PL2018-343

BUILDING ADDITION

LYNDALE OFFICE
BLOOMINGTON, MINNESOTA

RICHFIELD BLOOMINGTON
CREDIT UNION

A1.1

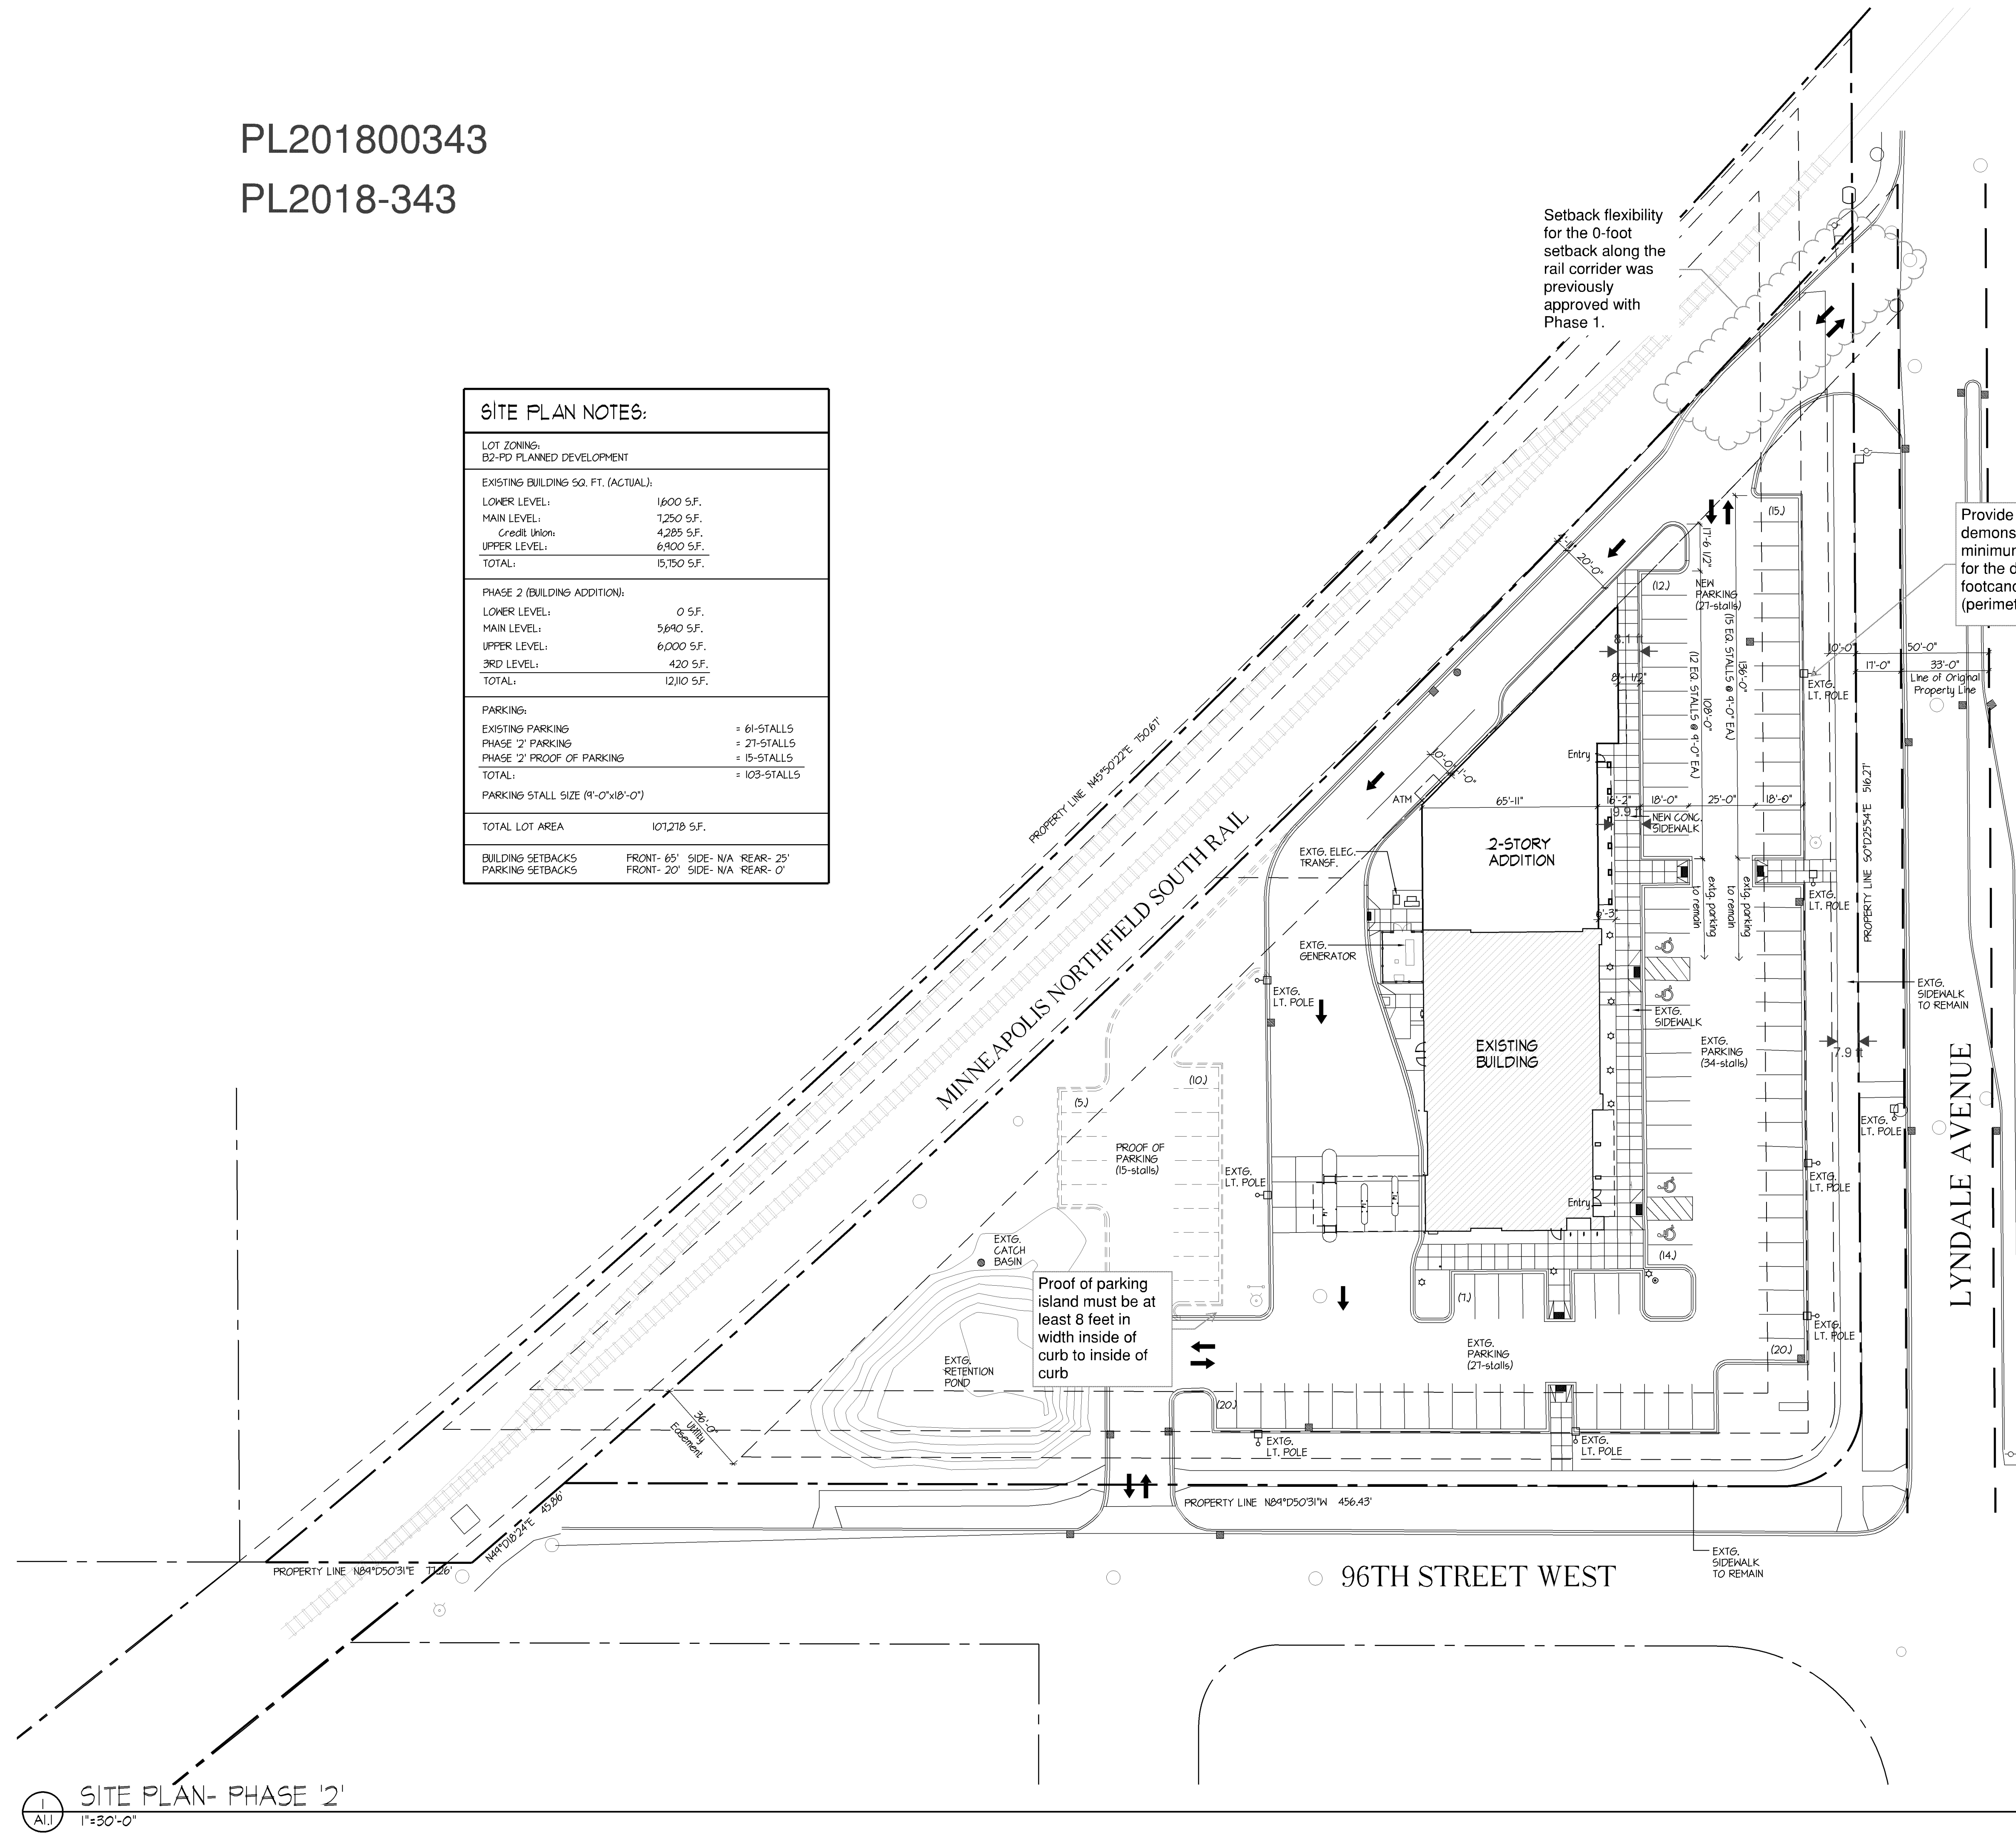
Must meet current MN S
Building Code

Provide a photometric plan that demonstrates the new parking area meets minimum lighting. 2.0 footcandles is required for the driveway and west stalls. 1.0 footcandles is required for the eastern stalls (perimeter stalls).

L1

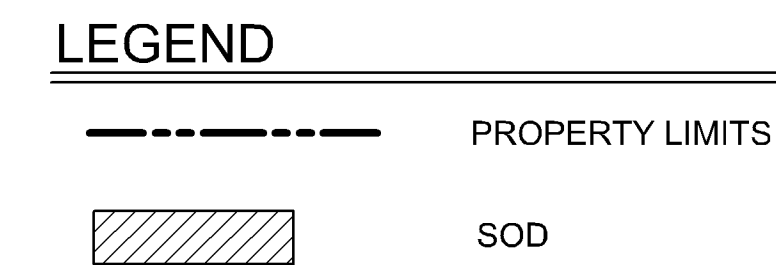
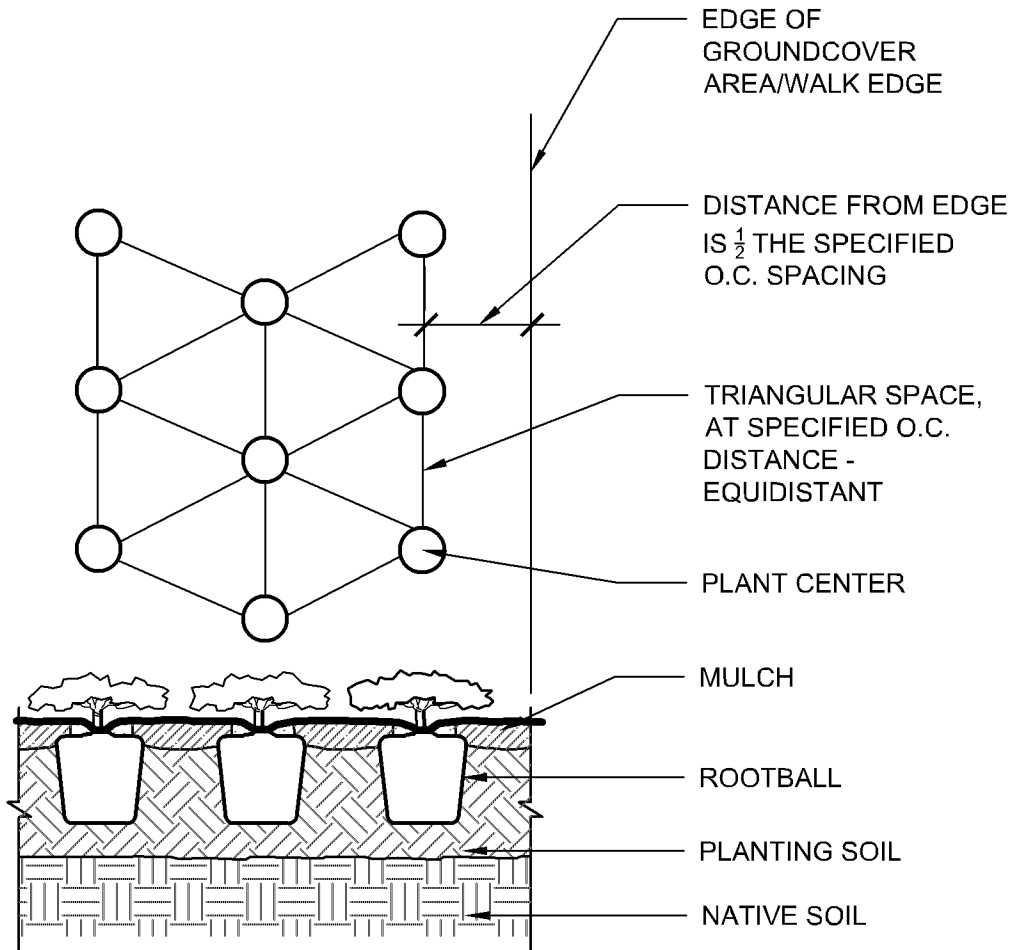
- Incorporate proposed landscaping with the phase 1 landscaping plan. The entire site must meet City landscaping requirements.
